Electricity Network Innovation Competition Full Submission

Supplementary Answer Form

Project: ANGLE-DC

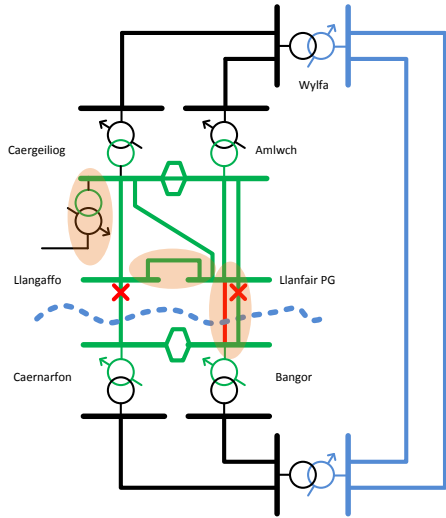
Question	With regard to base case costs, there appears to be a multitude of different figures given, although the ball-park figures seem grossly similar. The methods (as mentioned - Qu 1) are unclear. More specifically, however, the term 'base case' is used to mean both no investment and also conventional reinforcement. Furthermore, the amount for conventional reinforcement is ■■■ in the spreadsheet and Appendix 4, ■■■ on Pg 53, and a number is given for conventional reinforcement of ■■■ in the TNEI report (due to need for a 132 kV part of the system). Please could we get these figures checked (possibly simplified) and clearly explained?		
Notes on question	Not applicable.

Answer	Yes, there are two base cases in the proposal document. 1. 'Base Case' which is specific to the Anglesey area and described in the Project Business Case - Section 3 2. 'Base Case' which is relevant to the roll-out phase and described in the Benefit Tables – Appendix A 1. The business case presented in section 3 compares the proposed MVDC link solution illustrated in Figure C-4 against the submitted RIIIO-ED1 proposal, base case illustrated in Figure C-3. In this 'base case' Bangor-Llanfair PG circuit will be open in normal operation at no cost, hence no investment is considered. 2. In line with the Electricity NIC Governance Document the 'base case' costs in the benefits tables are defined as the costs of delivering the <u>same network benefits</u> through the most efficient method <u>currently in use</u> on the distribution system. A theoretical conventional reinforcement base case was therefore designed to deliver comparable benefits to the MVDC link. We have assumed using a MVDC link provides a 30.5MVA power transfer capability between two distribution systems. The alternative solution to the

MVDC link includes the addition of one new grid transformer at each end of the MVDC link. Costs have been prorated to the level of capacity released by the DC link and estimated at [REDACTED]. Regarding the differences in the amounts for conventional reinforcements: Theoretic cost estimations for the 'base case' in the Benefit Tables have been developed and estimated at [REDACTED] (as mentioned above). This 'base case' where a high aluminium, steel or copper content is assumed to follow a type 1 cost curve as per Figure D-3 (according to the Work Stream 3 report, issued on behalf of ENA in 2012). With regards to the discrepancy in 'base case' costs between [REDACTED] and [REDACTED], these have been calculated at different points [in the type 1 cost curve] in time considering [REDACTED] as the cost of delivering the scheme at present. The costs in page 53 have been calculated for a Post-Trial replication upon completion of the ANLGE-DC project in 2021: [REDACTED] x 109.6% = [REDACTED] The costs in the spreadsheet have been calculated for a replication in 2030 : [REDACTED] x 115.5% = [REDACTED]. The [REDACTED] figure given at the TNEI report is independent from the business case and benefits calculations and shows the total reinforcement cost for the wider Anglesey reinforcement as per figure C-3, including 33kV circuit works, 132kV circuit works and the addition of a new grid transformer in Anglesey.

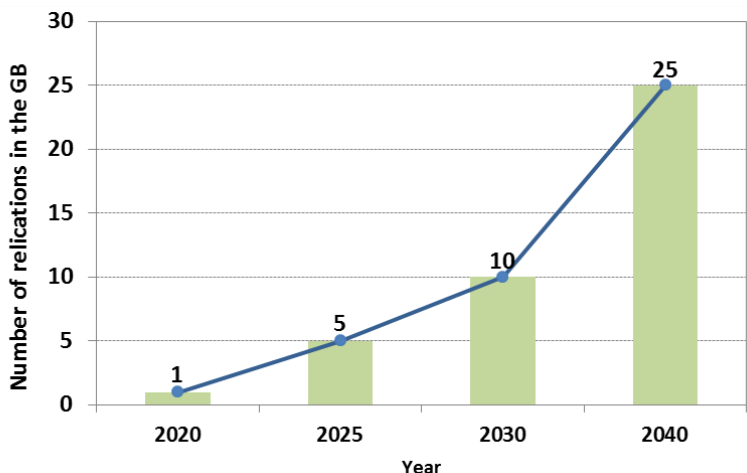
Question	A release of 30.5MVA of capacity is assumed for 25 other sites in GB. This would suggest these sites are all currently unable to be used in normal conditions, but alternative operating conditions are not ruled out . In the trial case an AC cable mitigates risk that the current circuit might fail upon conversion to DC, leading to unavailability of the link. It appears that the presented benefits will depend upon the capital expenditure being on the converter system only: how will circuit redundancy during the commissioning of the GB roll-out circuits be avoided? Has this been discussed with other DNOs?		
Notes on question	Not applicable.

Answer	The AC cable will not only ensure the security of supply during the ANGLE-DC trial but will also act as part of the testing system to demonstrate the optimal load flow control, and facilitate the understanding of the thermal limit of the converted circuit. The successful trial in ANGLE-DC will prove the reliability of the technology as a means to demonstrate security of supply will not be compromised in future projects, even in the absence of an AC cable. It is not expected that parallel AC circuits will be required for future rollout. During commissioning of future rollout projects an outage of the circuit to be converted will need to be scheduled. The outage will be planned in advance to minimise disturbance on the newtork. This is standard practice in the operation of the electrical network. The duration of the outage could be minimised with the site preparation and installation works of the DC converters taking place with the circuit is still in AC operation. The outage would only be required to transfer the circuits

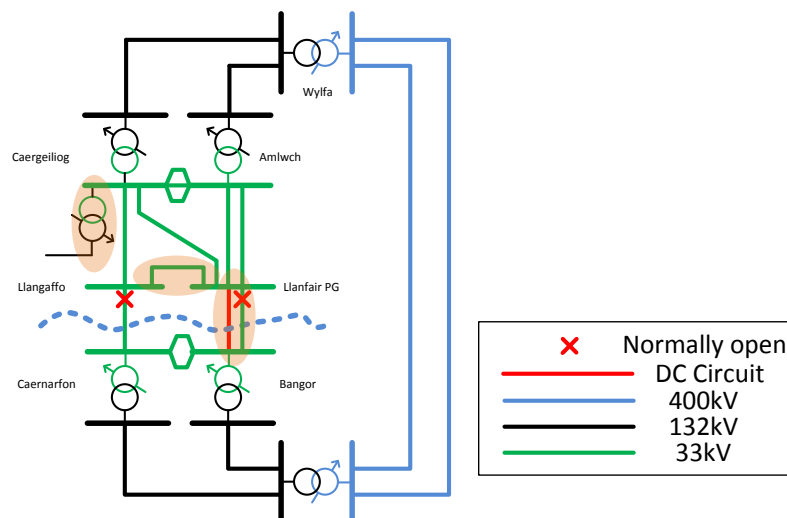
Question	The ED1 settlement provided funding for reinforcement works on Anglesey. We understand that these works are not proceeding as planned and that the Angle DC project is instead providing more AC and DC capacity to the island. Please explain why SP is seeing no Direct Benefit from the Angle DC project.		
Notes on question	Not applicable.

Answer	It should be clarified that while the ED1 settlement includes funding for certain reinforcement works on Anglesey, the ANGLE DC project will be an incremental approach and is currently not in a position to replace those conventional reinforcements due to its existing TRL. The works proposed in the ANGLE-DC project are not replacing the need of conventional works but offering improved/additional controllability which enables to maintain an existing circuit in operation and keep the electrical separation between the island and the mainland. Conventional works proposed in ED1 will still proceed on the island (such as construction of a new GSP and construction of a new 33kV overhead line) independently from the ANGLE-DC works. The ANGLE DC trial could provide incremental capacity, which will be considered for conventional network planning upon successful demonstration of the technology. SP Manweb has every reason to believe that Medium Voltage DC technology can be part of our toolbox of reinforcement solutions for future consideration. The details about the Anglesey reinforcement are included in Appendix C. An extract of the Appendix can be found below:

A scheme to reinforce the demand group on Anglesey was designed in 2011/12 and submitted as part of the RII0-ED1 business plan. The proposal was to establish a new grid transformer at Llanfair PG and a new 33kV circuit on the island. The submitted scheme was expected to significantly increase the thermal demand capacity on Anglesey and facilitate the separation of the Anglesey 33kV group from the mainland.
